City of Portland, Maine – Building or Use Permit Application 389 Congress Street, 04101, Tel: (207) 874-8703, FAX: 874-8716

Location of Construction: 14 Veranda Street		Owner: VJD Enterprises		Phone: 797-8552		Permit No: 981181	
Owner Address: 201 Harvard St. Portland		Lessee/Buyer's Name:		Phone:		BusinessName:	
Contractor Name: VJD Enterprises		Address:		Phone:		<div style="border: 2px solid black; padding: 5px; text-align: center;"> PERMIT ISSUED Permit Issued: OCT 14 1998 CITY OF PORTLAND </div>	
Past Use: Business/Restaurant		Proposed Use: Same		COST OF WORK: \$ 4,200.00			
				FIRE DEPT. <input type="checkbox"/> Approved <input type="checkbox"/> Denied		INSPECTION: Use Group: Type:	
Proposed Project Description: Remove interior partition and stairwell, build new partition and exterior stairway.				Signature: <i>[Signature]</i>		Signature: <i>[Signature]</i>	
Permit Taken By:		Date Applied For: 10-13-98		PEDESTRIAN ACTIVITIES DISTRICT (P.A.D.) Action: Approved <input type="checkbox"/> Approved with Conditions: <input type="checkbox"/> Denied <input type="checkbox"/>		Zoning Approval: Special Zone or Reviews: <input type="checkbox"/> Shoreland <input type="checkbox"/> Wetland

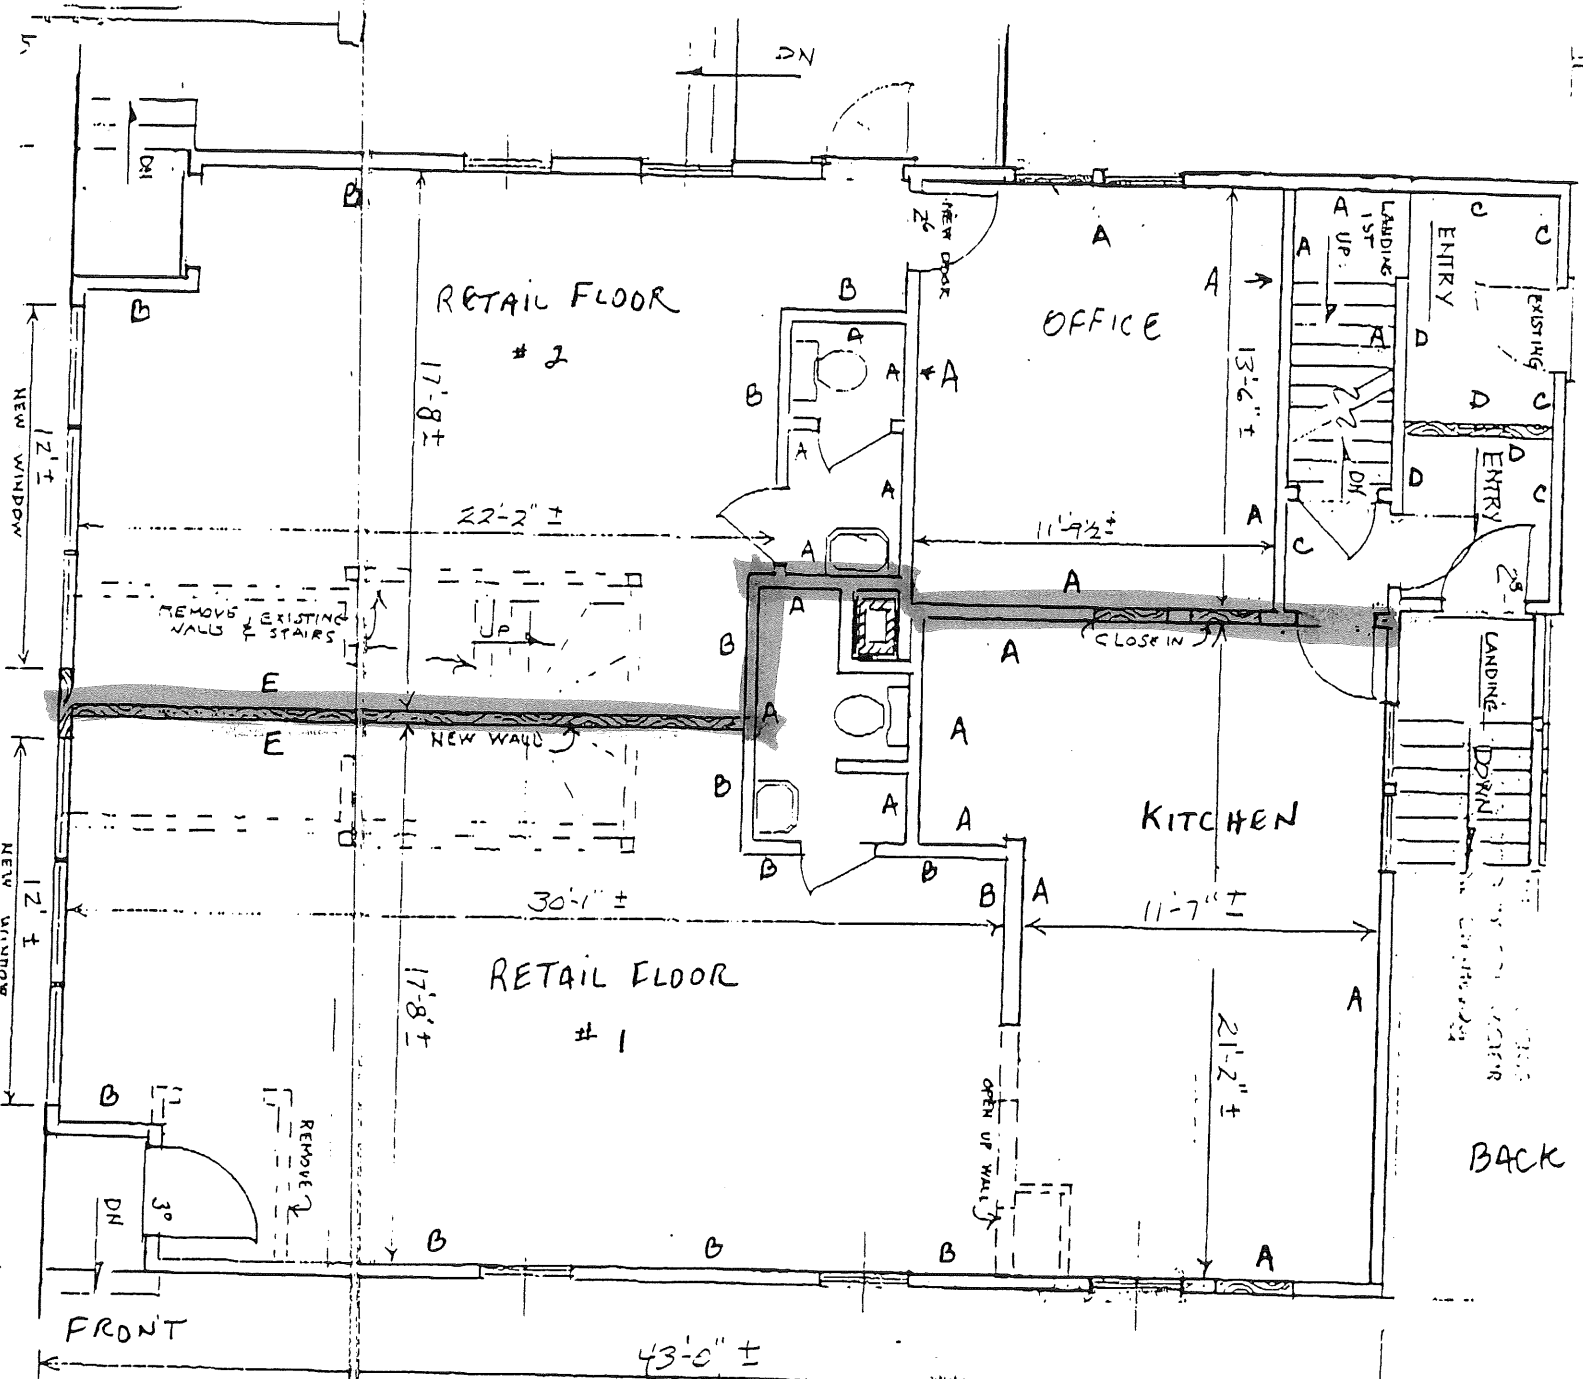
It is our understanding that city officials have requested two-hour design for the walls dividing retail units 1 and 2 from each other and the ceiling condition between the units and the apartments above. This discussion and the attached documentation are limited to those items.

For the ceiling system we recommend that the existing plaster and lath be removed to lighten the dead load on the ceiling. It is our understanding that the joist system in this building is 3x8's on 16" on center. Thus, we recommend using either Detail SC5710 or SC5724. Essentially, the details are the same, structural elements. What we would be doing is replacing the plaster in lath with a layer of 5/8", Type X, gypsum wallboard, resilient channels 24" on center and another layer of 5/8" gypsum wallboard to get us the two-hour rating depicted in the approved floor system types.

As for the walls, we recommend that all the walls, highlighted on the plan, the existing plaster lath, existing wall board, existing tongue-in-groove pine and whatever element is on the walls be removed and at that point be replaced per Detail WP4235 or WP4136. Essentially, adding a double layer of 5/8" gypsum board to each side of those walls as indicated. This would need to be done floor to ceiling. This would give us a two-hour separation wall between Units 1 and 2 and a two-hour ceiling between Retail Units 1 and 2 and the residences above.

The fire rating required in the stairways applies as well and same method should be used.

REWORK HIGHLIGHTED WALL TO 2-HOUR WALL

11/19/98 - Recd Fire Wall design from Sheridan - Reviewed & ok by PSH & Lt. MAC
work Completed - FSE Done ok for 1st only -

*Same
Address - info
provided by Sheridan
of fire rating OK
OK
MWB
Sam*
